Technical Note

CLIENT:	Extra MSA
PROJECT:	Proposed Erection of a Motorway Service Area, Land to the North of Junction 11 of the M62, Warrington
SUBJECT:	Groundwater Technical Note in response to EA letter dated 14 Feb 2020 SO/2019/119672/03-L01
JOB NO.:	SH11739
DATE:	20 March 2020
PREPARED BY:	L Ballarini: Service Area Lead – hydrogeology and hydrology

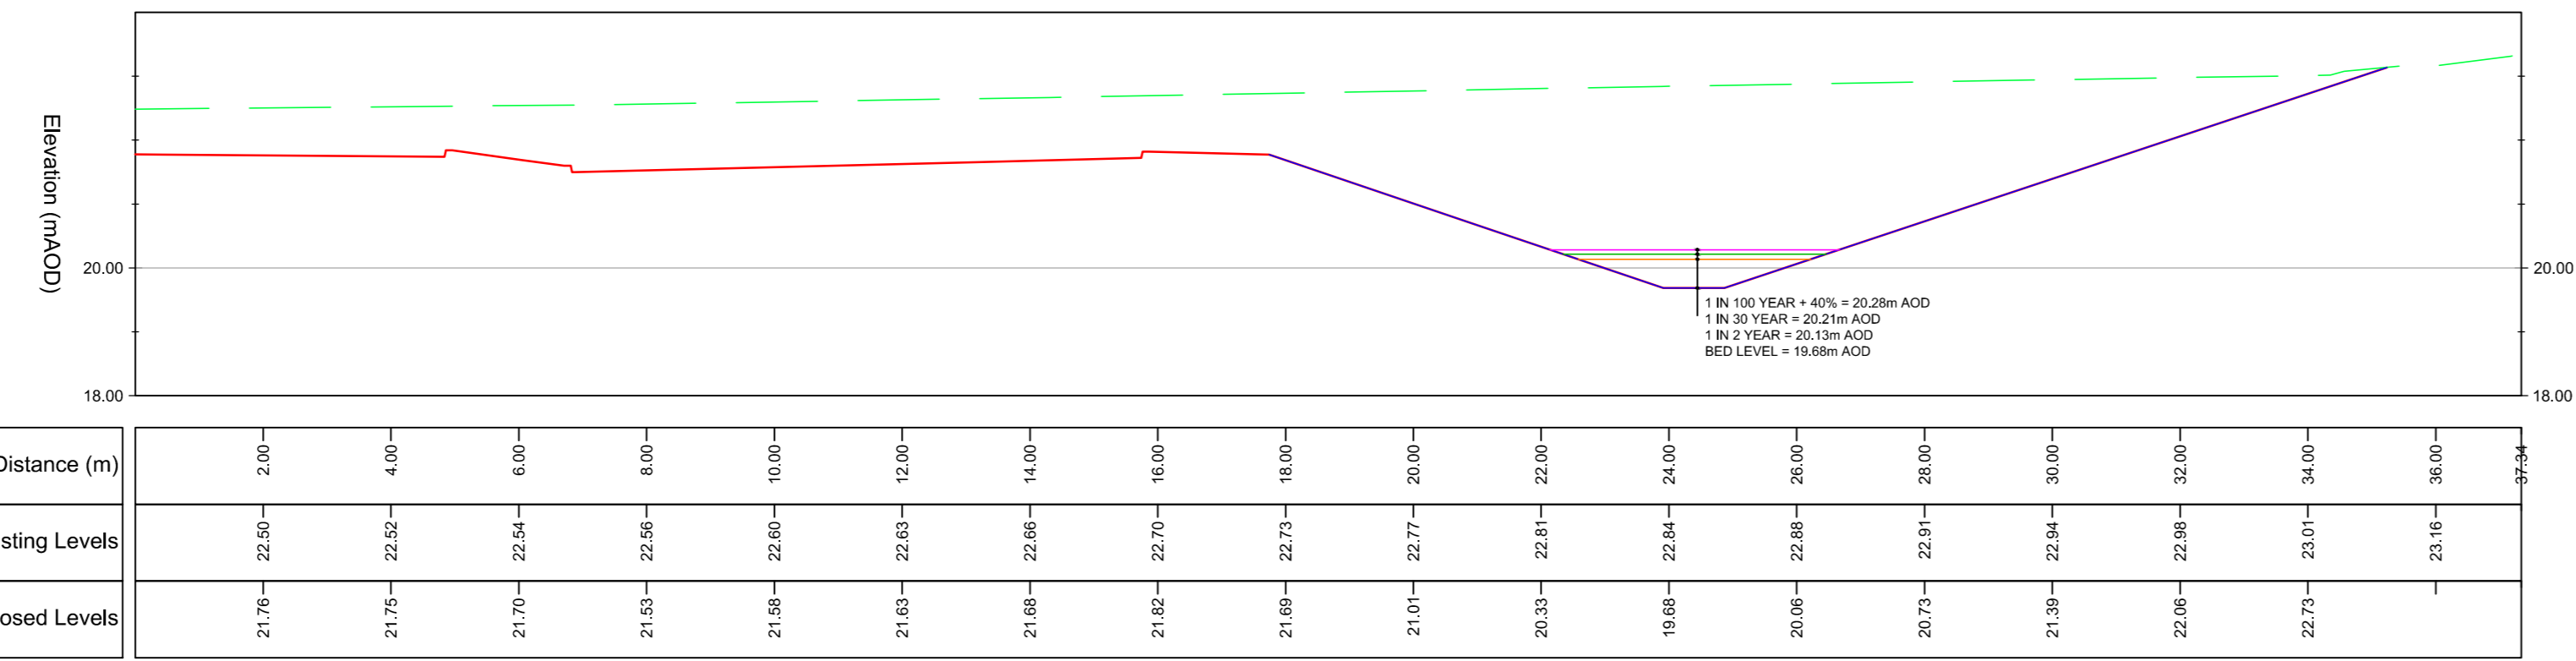
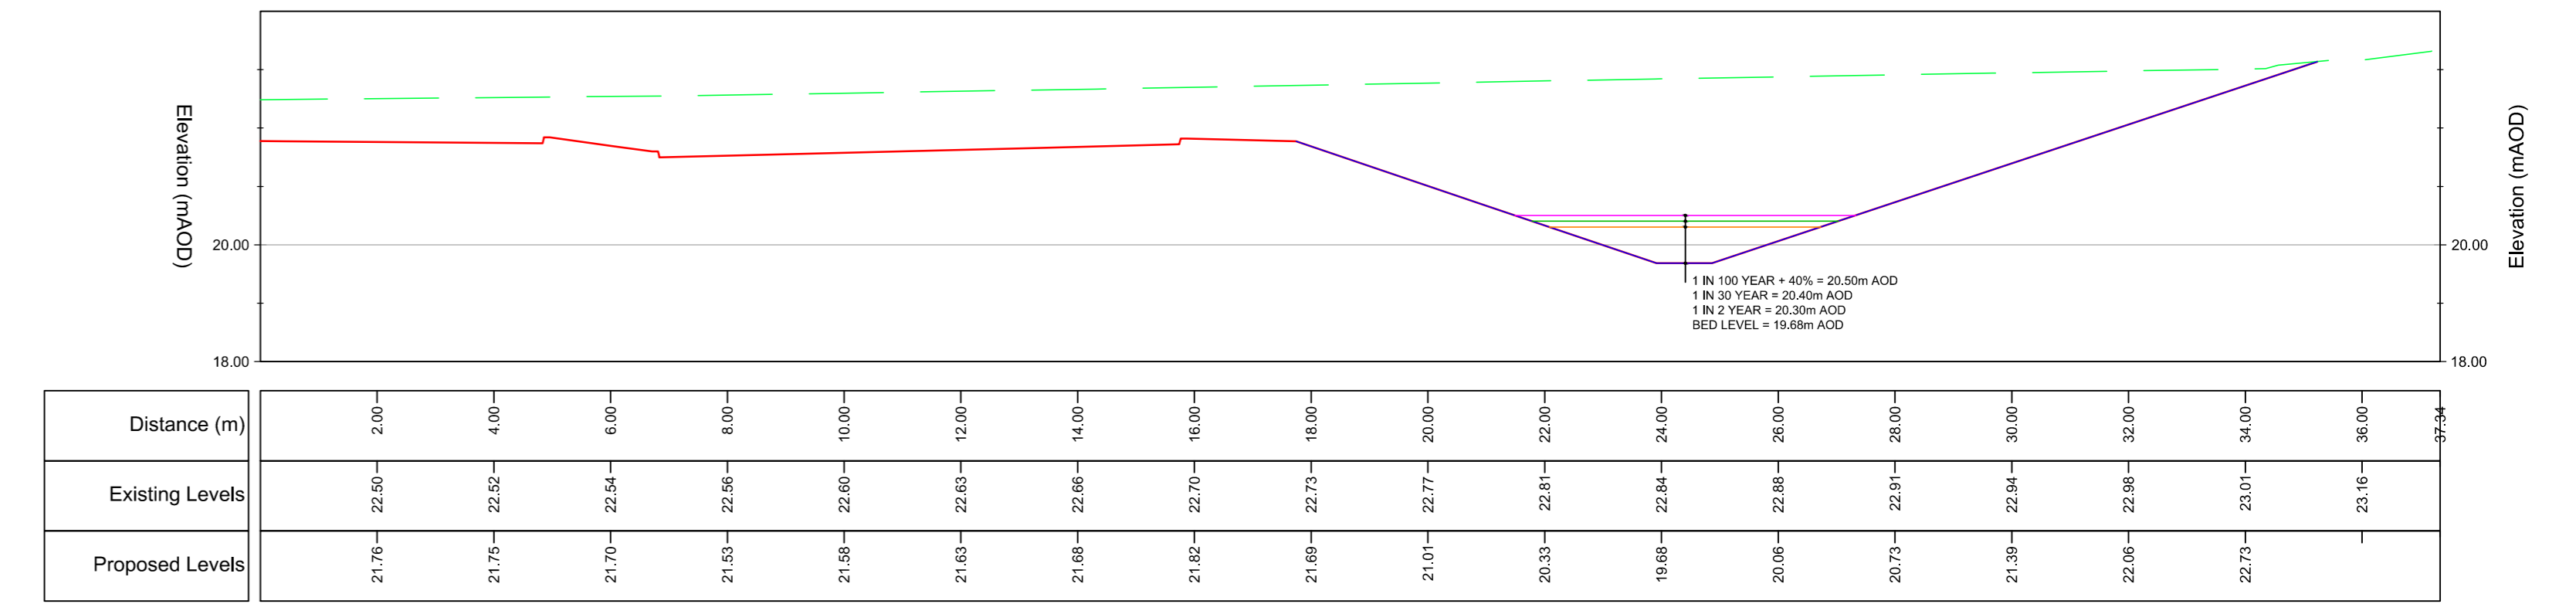
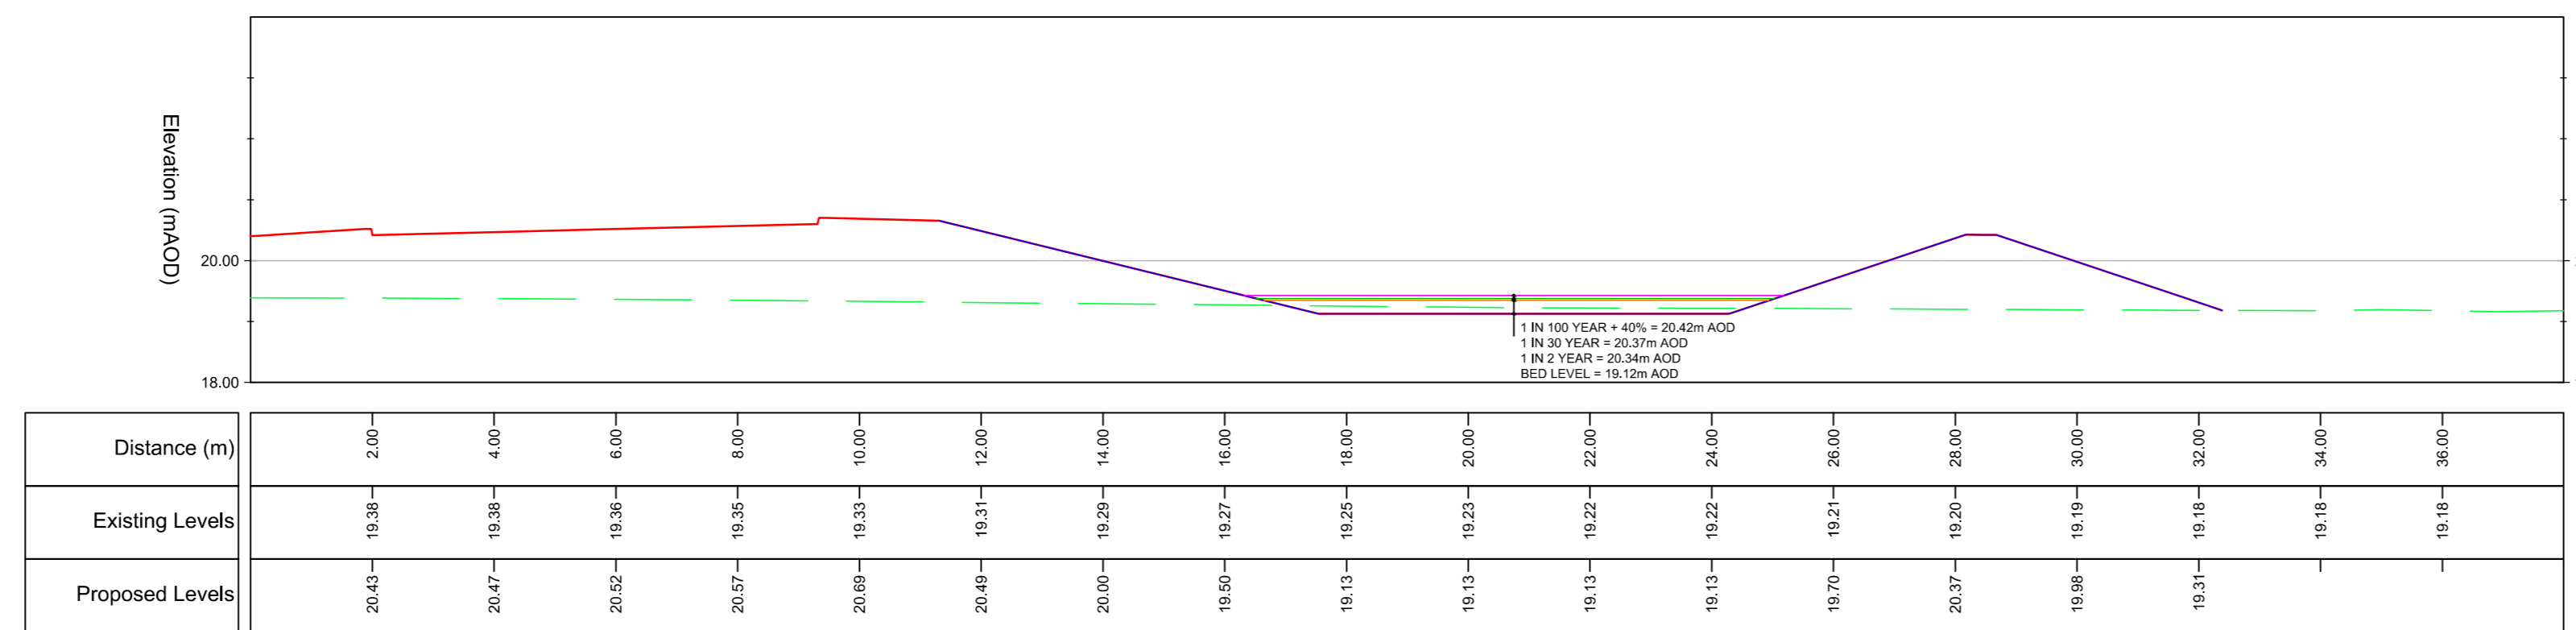
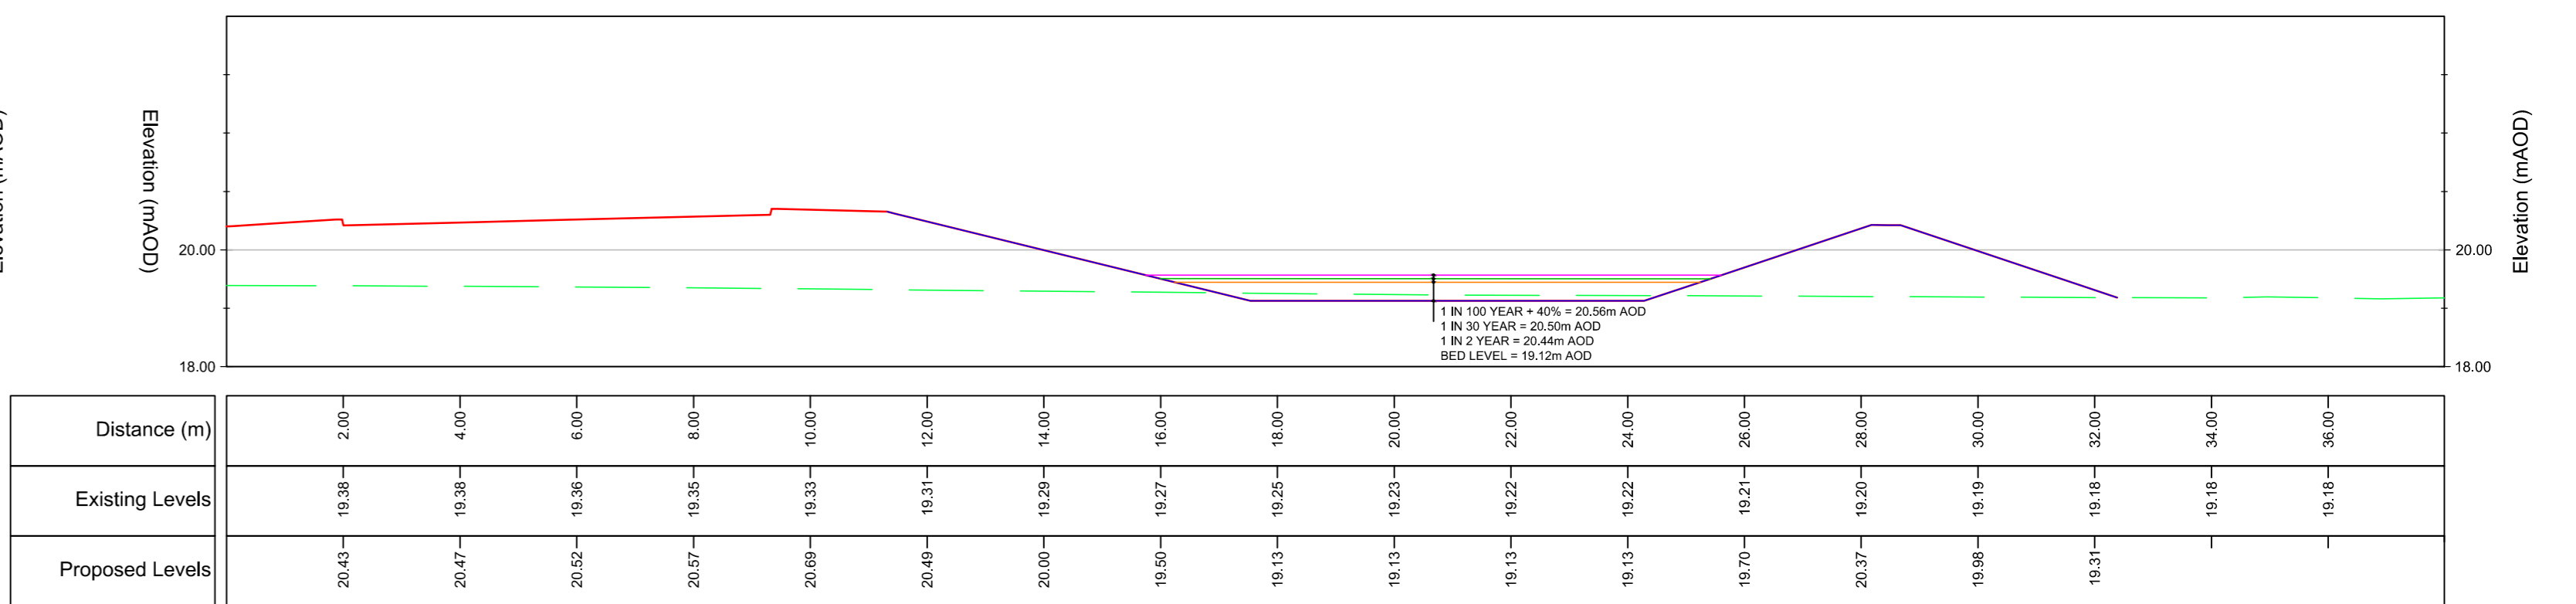
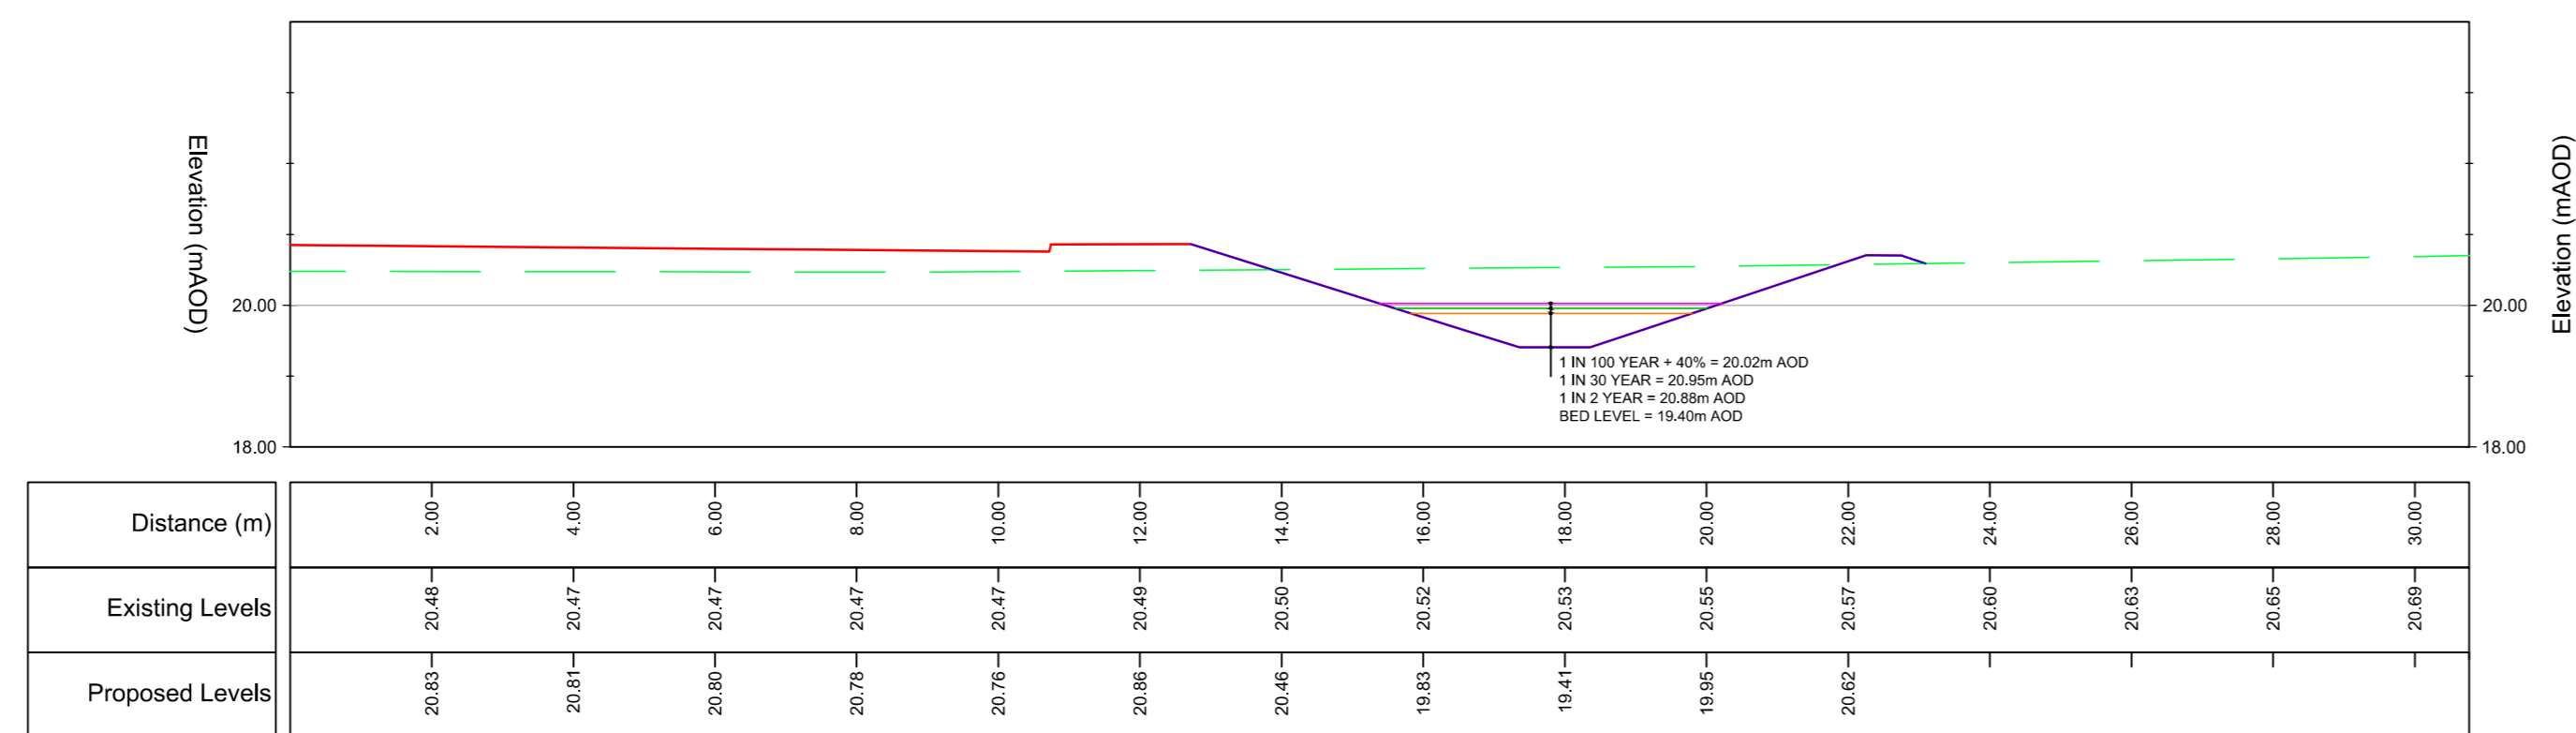
EA comment: [Provide information on] finished floor level data including expected level of brook.

Section 3.6 of the flood risk assessment details the design of the watercourse and, to clarify the indicative water depths expected within the proposed channel, we attach an additional drawing, SH11739-064 titled 'Silver Lane Brook Watercourse Sections'. This drawing details the estimated water level depths based on a Mannings channel roughness coefficient of 0.04 and 0.08 and shows the water depth for the estimated 1 in 100-year storm event plus 40% climate change discharge rate from the restored landfill site. This shows water depth to be well within the channel's capacity for both roughness coefficients, including a freeboard allowance.
